E5071B-08D

S E R V I C E N O T E

E5071B ENA Series Network Analyzer, 300 kHz to 8.5 GHz

When a measurement trace or output power shows troubles between 1.3 GHz and 2.1 GHz, replace A1 module with the latest one (E5071-6x571), and update E5071B Operating system at the same time.

Figure 1. Trace shows noise around 1.3 GHz to 2.1 GHz at preset setting.

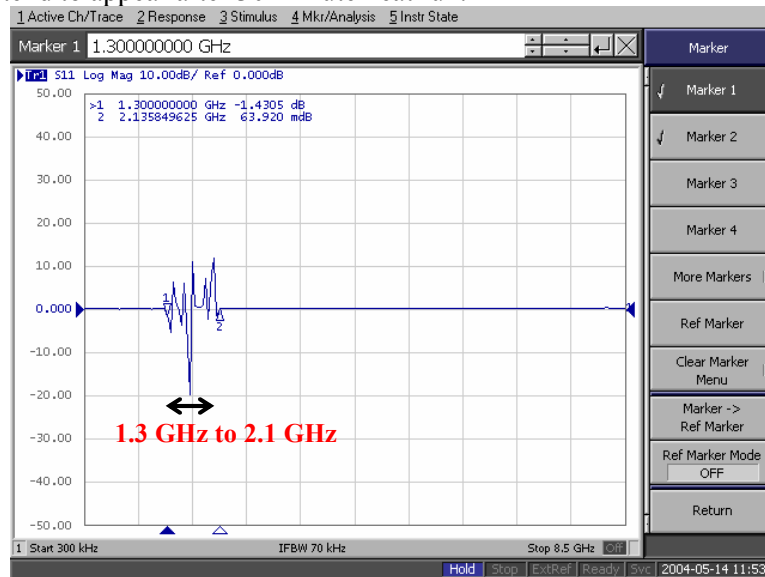
- The trace shows spike at 1.3 GHz or 2.1 GHz at the preset situation.
- The trace between 1.3 GHz to 2.1 GHz is more noisy than other frequency ranges.
- The power level of 1.3 GHz to 2.1 GHz is lower than other frequency ranges.
- Internal test of A1 ALC shows fail at SOP (f=1.3G) or LOP (f=1.3G) as Figure 2.

Above symptoms tend to appear after 30-minute heat run.

Replace the defective board with E5071-6x571, new A1 module. Also, update the operating system in accordance with the service note E5071B-10A to implement the firmware revision 5.00 or later. *1

Replace the defective board with E5071-6x571 only.
